RE: Independent Hydrogeological Review of  
Recent Data and Studies Related to California  
American Water's Proposed Monterey  
Regional Water Supply Project  
Weiss Job No. 466-2148

This draft report documents Weiss Associates (Weiss's) independent hydrogeological review of data and studies related to California American Water's (Cal-Am) proposed Monterey Regional Water Supply Project (MRWSP). The MRWSP is expected to extract predominately seawater pumped from a planned well field near the Monterey Bay shoreline in the City of Marina California.

**Figure 29**

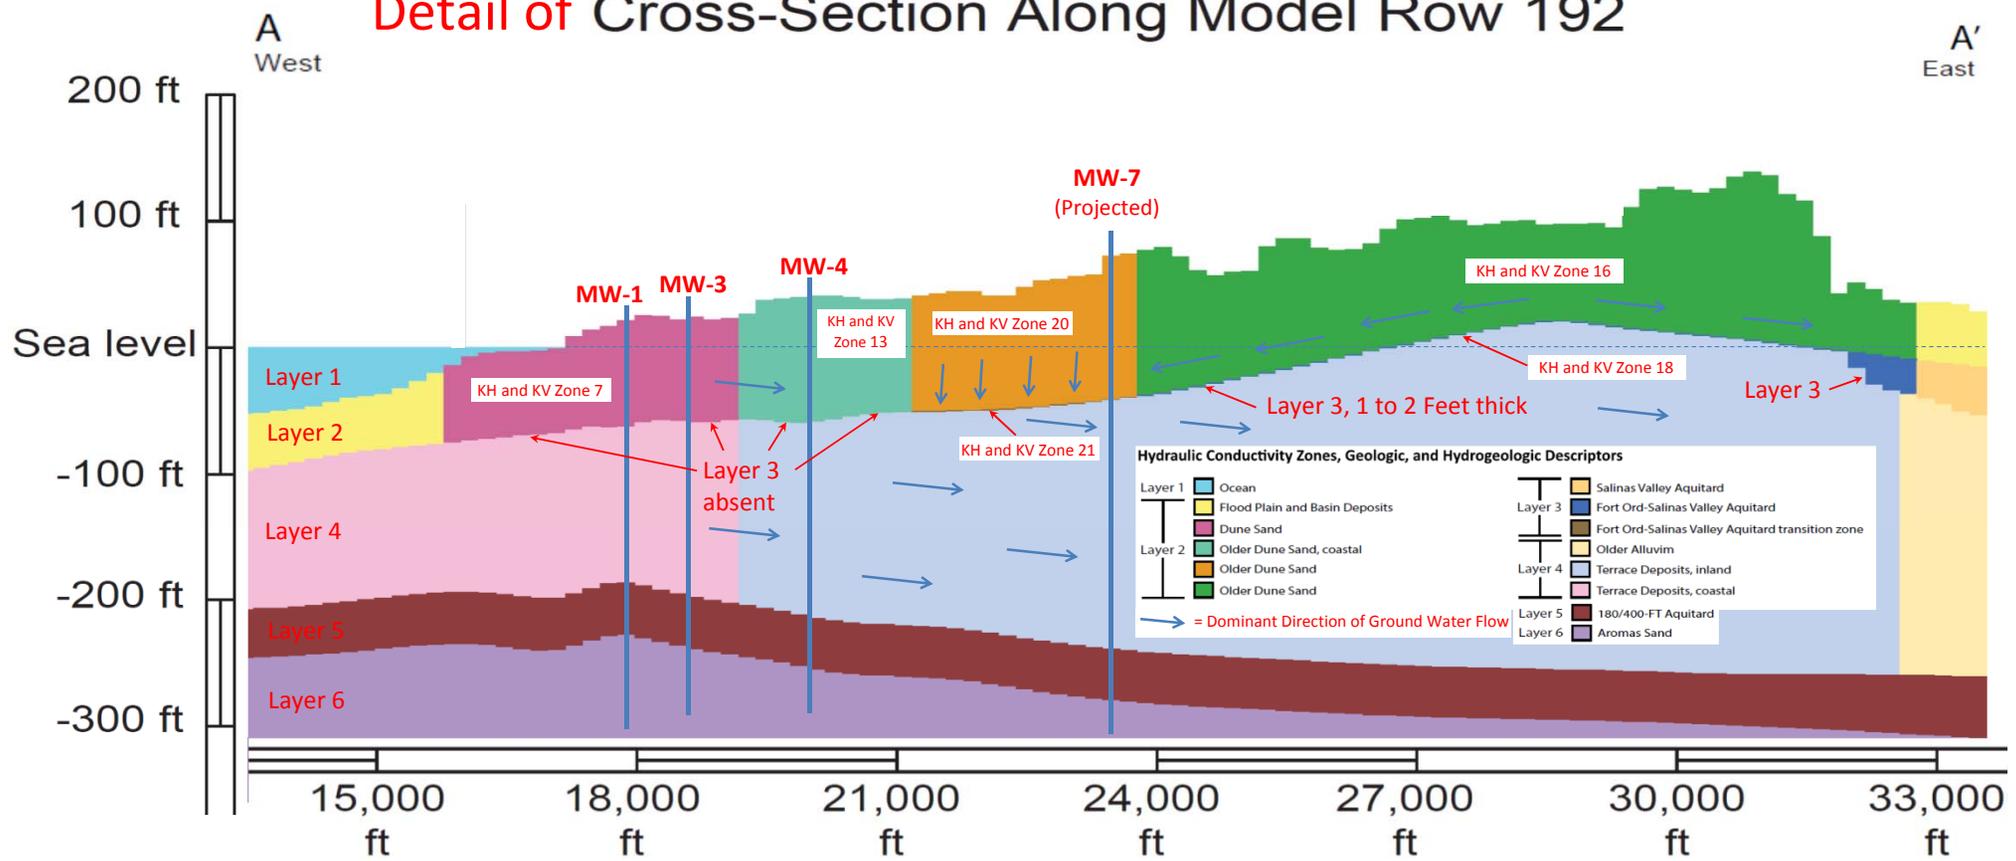
- The vertical hydraulic conductivity (VK) assigned to the FO-SVA in Zones 18 and 21 (Figures 28 and 29) is 0.0000005 and 0.0005 ft/day. This indicates that the FO-SVA is considered essentially impermeable in Zone 18, such that groundwater flow above it in the Dune Sand Aquifer (Zone 16 of the model; Figure 29) will be predominantly horizontal. In Zone 21, which includes MW-7, the vertical groundwater gradient across the FO-SVA is on the order of 1 to 10, given modeled thickness of the FO-SVA of 1 to 2 feet at that location, in contrast to the far lower horizontal gradient within the overlying Zone 20 (Dune Sand Aquifer), measured in the range of up to 0.0012. The result of this is that movement of groundwater out of Zone 21 is approximately 2 orders of magnitude greater vertically downward than in the horizontal direction (Figure 29).

Figure 30

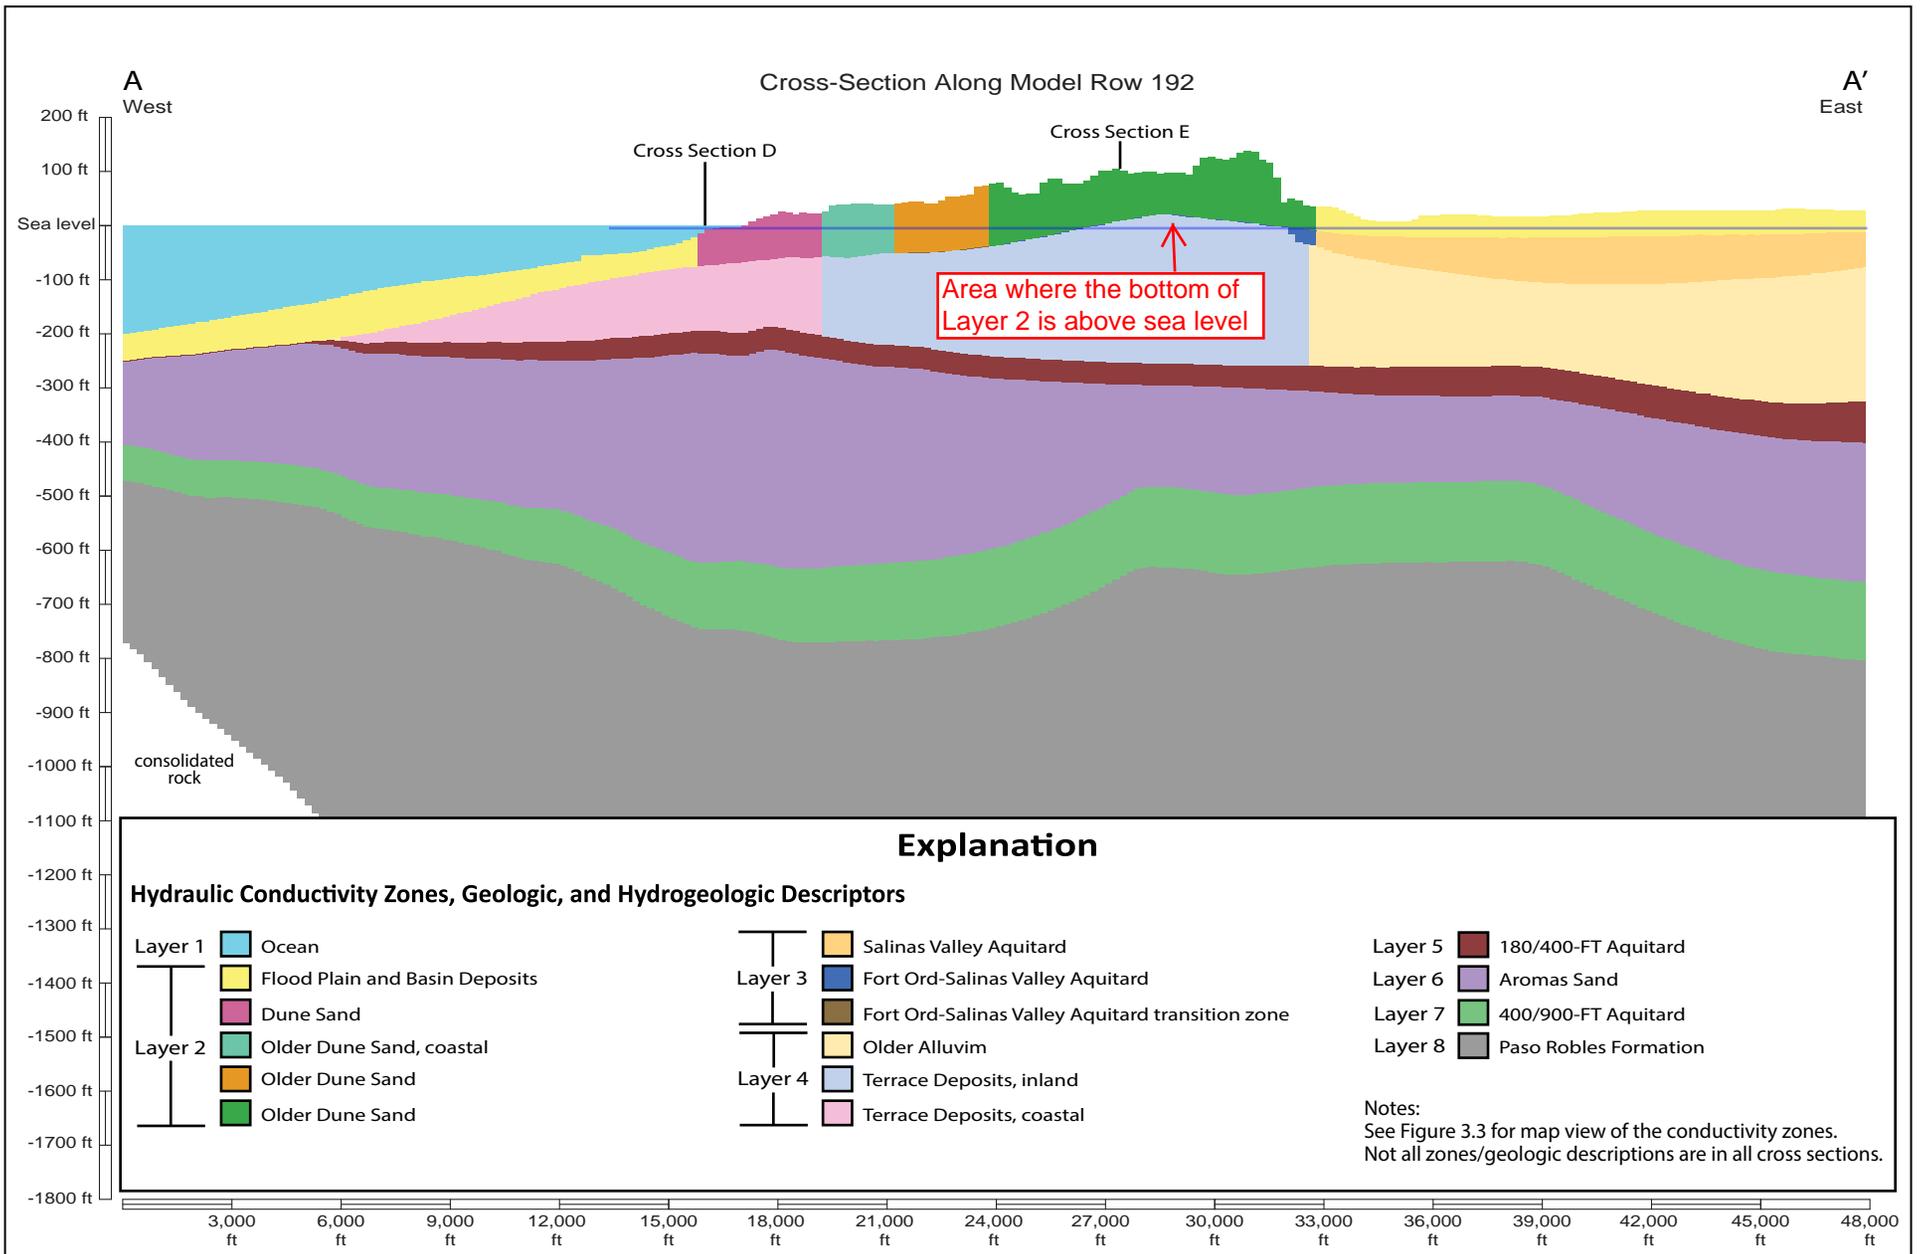
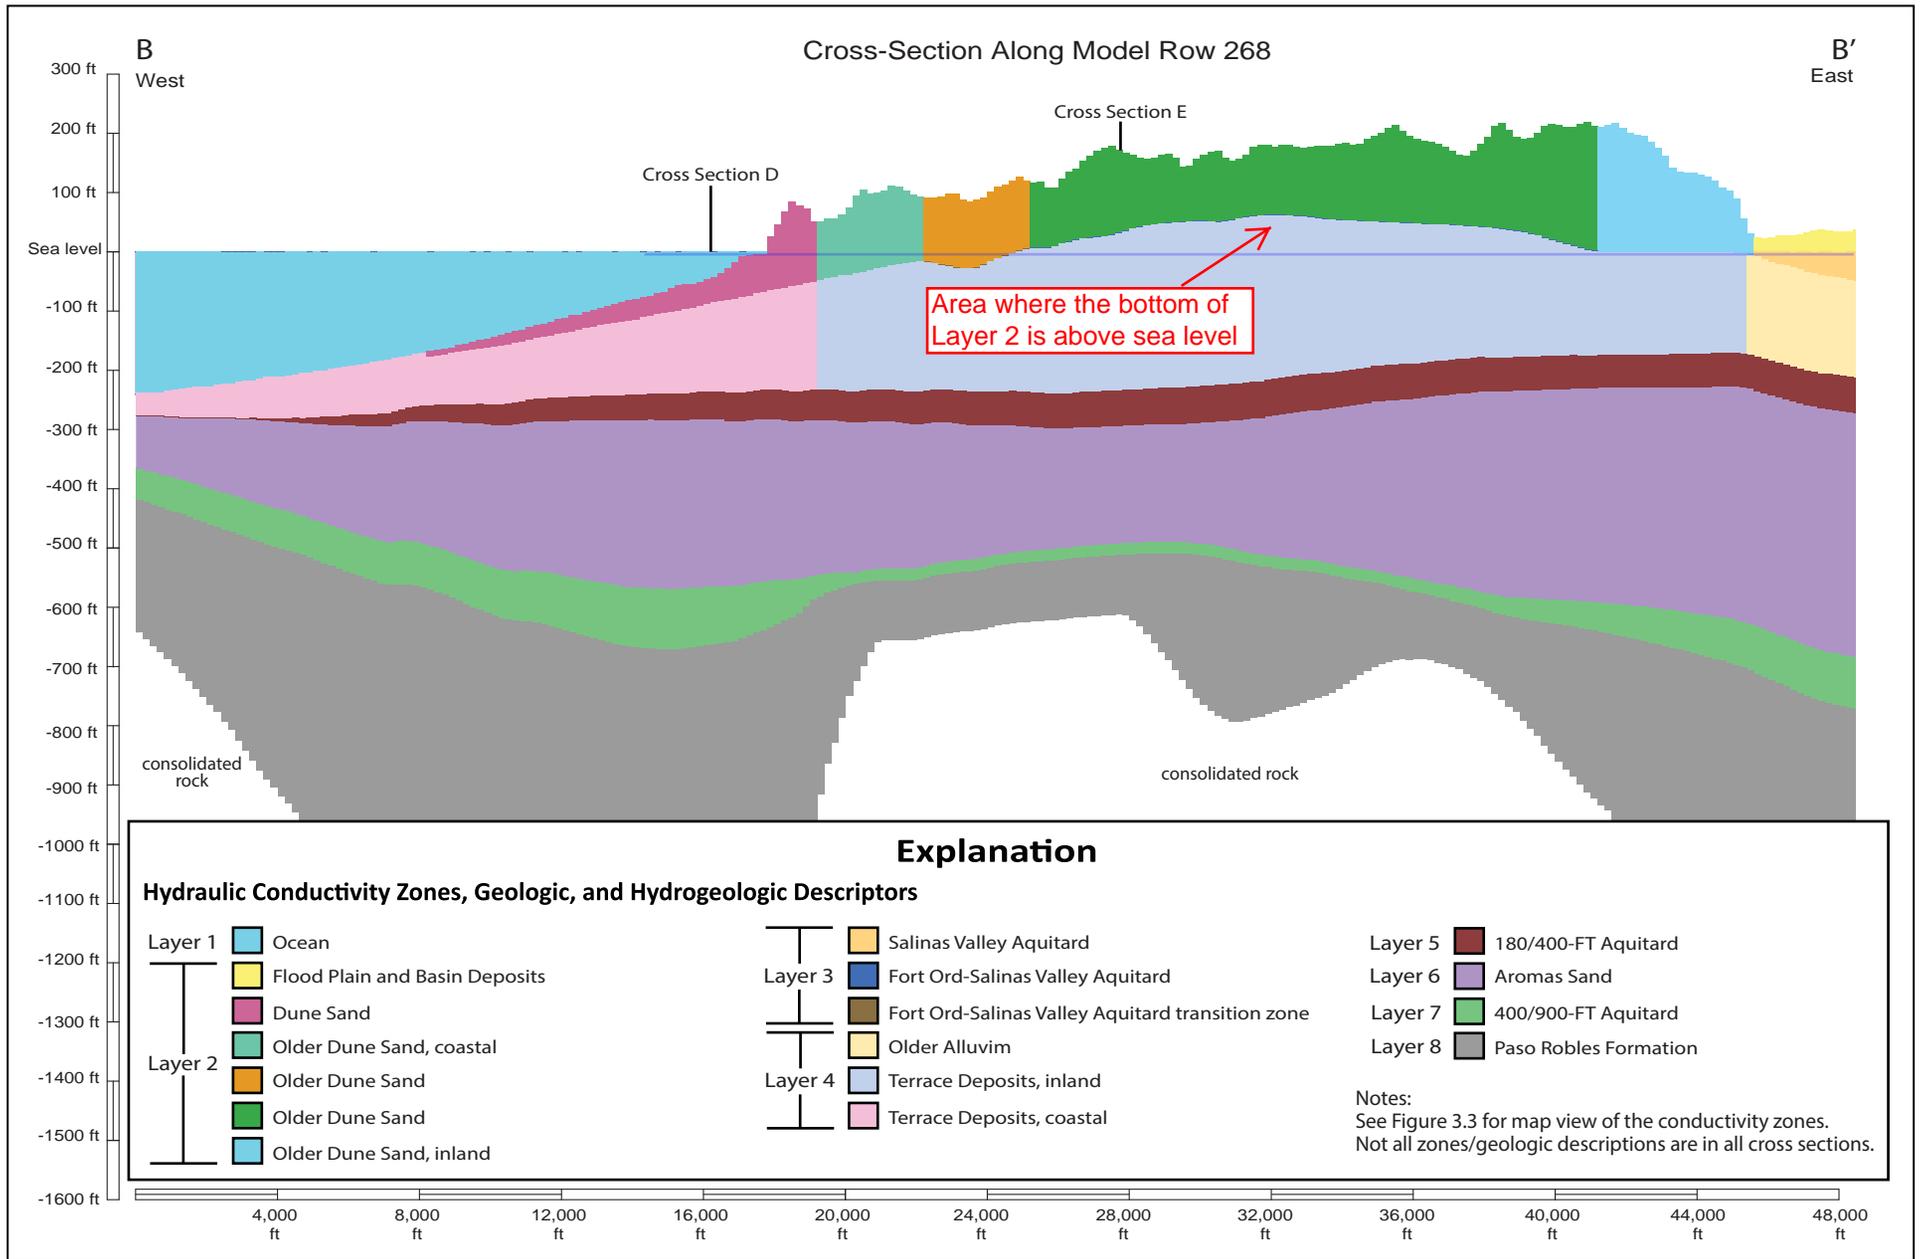
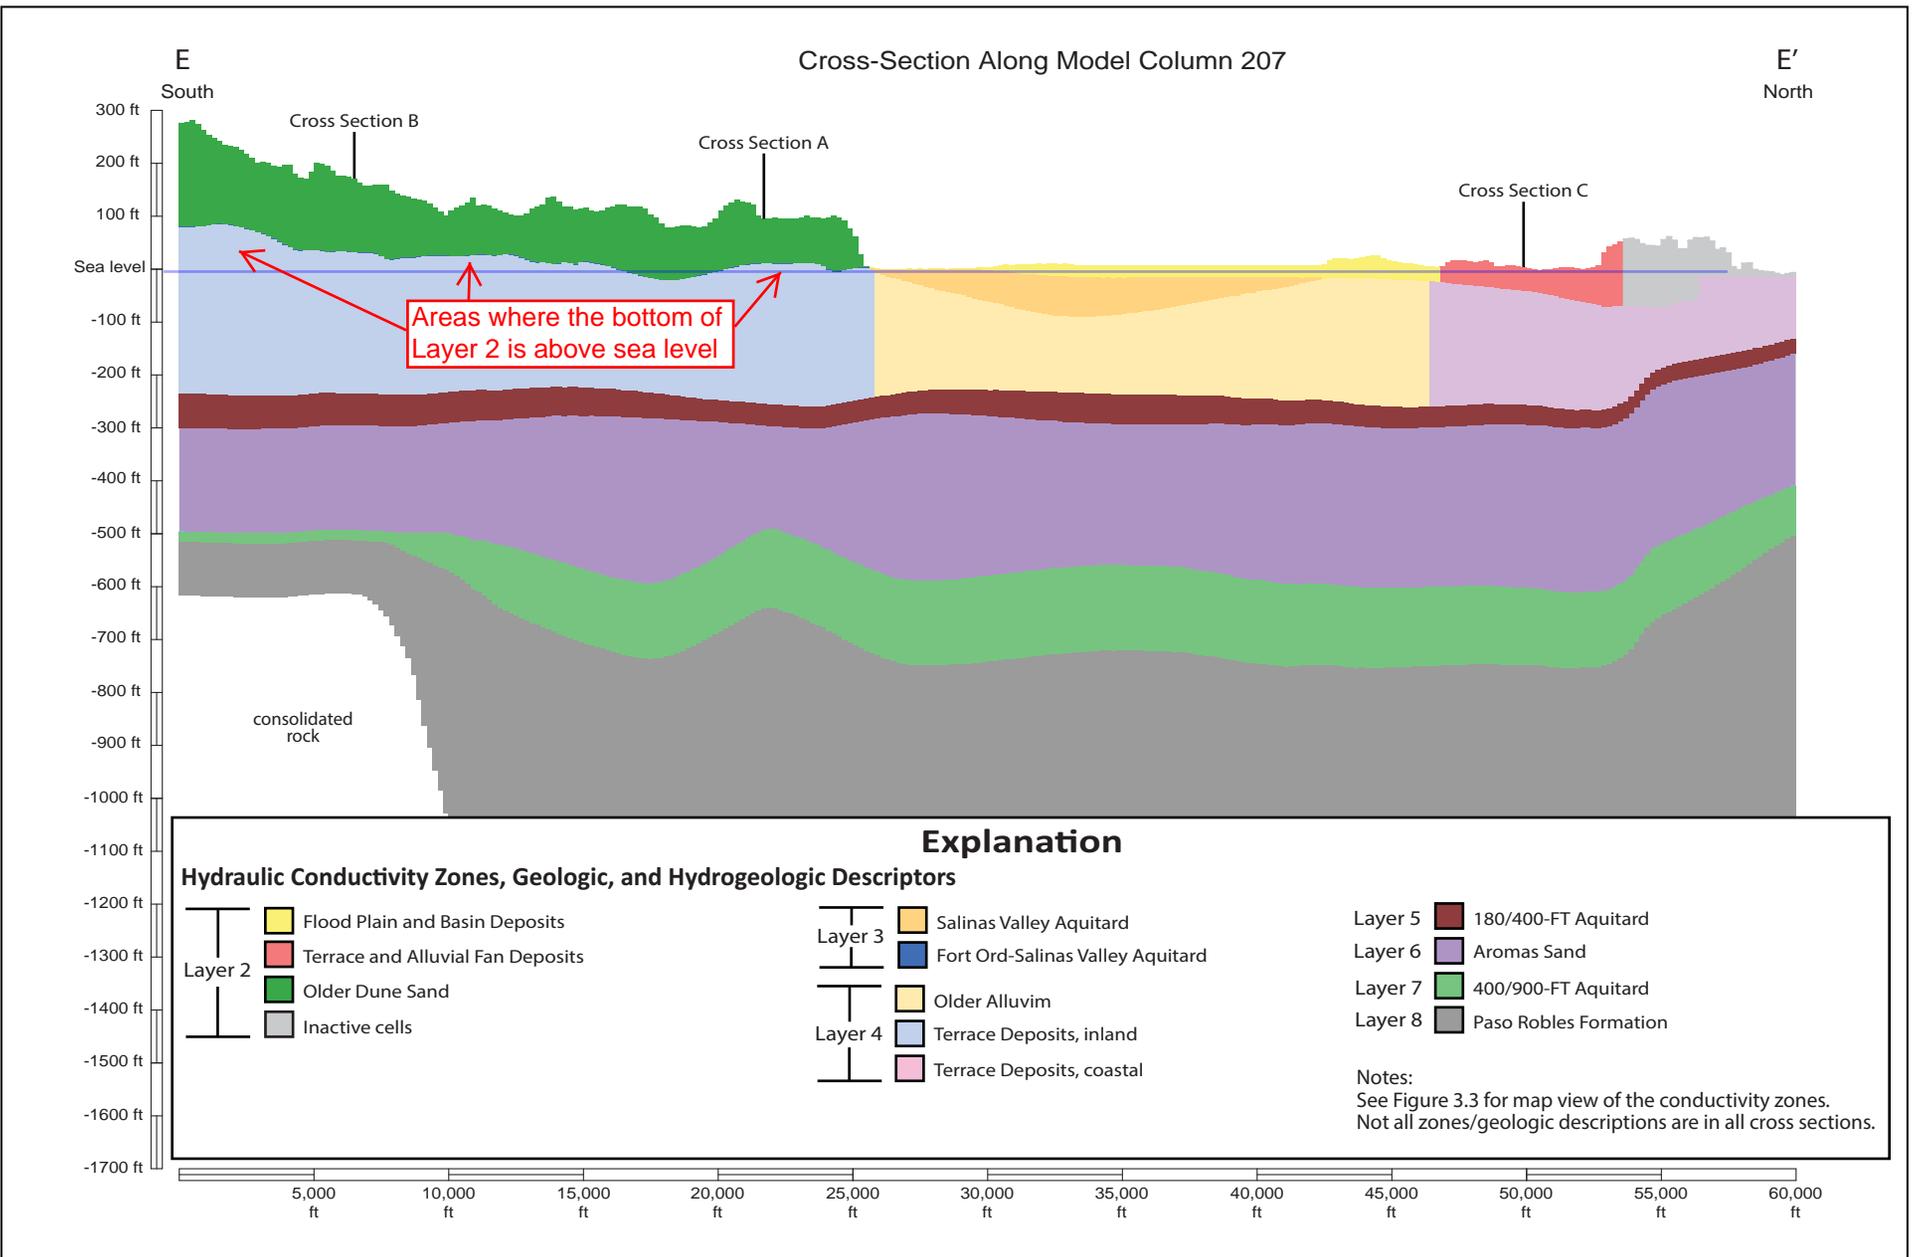
Another limitation of the superposition approach for Layer 2 is that initial water levels are set at zero, equal to sea level. As shown in annotated model cross sections A-A’, B-B’, and E-E’ (Figures 30, 31, and 32), this places the bottom of Layer 2 above sea level, above the initial head setting for the model, indicating it would be unsaturated. The estimated areas where this condition occurs is shown on Figure 33. However, superposition analysis results show physical inconsistencies, such as cones of depression that includes these unsaturated areas (Figures 34 and 35), and drawdown of 2 feet in well MW-5S (Figure 34), which is presumably screened in a perched aquifer zone hydraulically separate from the Dune Sand Aquifer. The only way these results could have been achieved with the superposition approach is that some modification to model layers must have taken place that was not documented, along the lines of lowering the riverbed in the example superposition analysis provided in Appendix E2 of the Final EIR/EIS (Attachment 1).<sup>(7e)</sup> The effects of such modification are not documented and cannot be evaluated.
